GFA AD 515

GFA AIRWORTHINESS DIRECTIVE

Obstruction of emergency canopy jettison.

Rolladen-Schneider			Page 2 of 2
Flugzeugbau GmbH	Technical Bulletin No. 8004 / 2	LS8	
LBA-Nr. EB-4 / I-B16			Edit. 12.Feb.2001

Modification of the Deflector

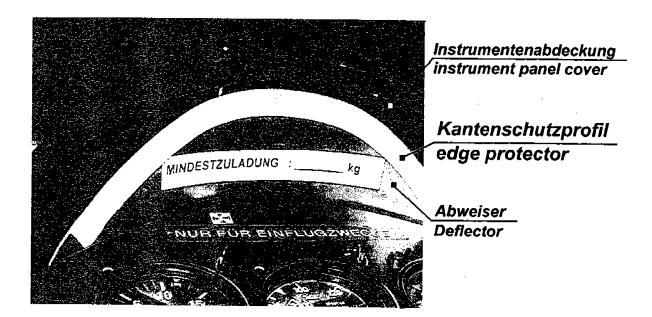
- 1. Drill blind rivets. If need be, unscrew upper instruments (Hexagon head 2.5 mm und ratchet with 7mm socket) and place them on top of the second row.
- 2. Mark new fixing holes 10mm (0.4 in) offset from originals and drill. This enables to use the existing holes at the instrument panel edge.
- 3. Shorten straight edge of deflector by 10 mm, soften edge and paint black. Maximum depth of deflector after trimming is 100 mm (3.94 in).
- Rivet deflector back to top of instrument panel, facing towards the pilot (Blind rivets Ø 4mm*6.5, large washers Ø4.3 * 12 * 1mm DIN 9021-St).
- 5. Push edge protector (as long as instrument panel allows) onto deflector edge.

Deflector with edge protector:

Should the instrument panel cover be too short to allow the protector to fit underneath, contact manufacturer stating model and serial number.
